UN ECE GRRF AEBS and LDWS Informal Working Group

CLEPA proposed amendments to AEBS “skeleton” document AEBS-LDWS-02-02e with regard to technical requirements

PROPOSAL 29-10-2009

6.5.7. Adjacent vehicle curve test (false warning test)

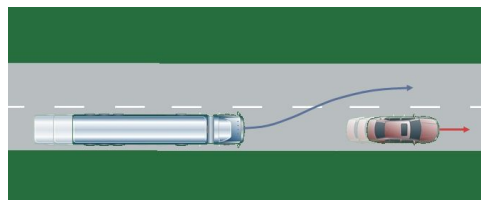
6.5.7.1. The subject vehicle shall approach and pass the target vehicle at a closing speed of 10 km/h when both vehicles are travelling in the centre of adjacent lanes, each 3.5m wide, with the inner marking of the inside lane having a 125m radius of curvature. The target vehicle shall travel at a constant speed of 40 km/h.

The test shall be conducted twice, once with a right hand curve and once with a left hand curve.

6.5.7.2. There shall be no action from the AEBS.
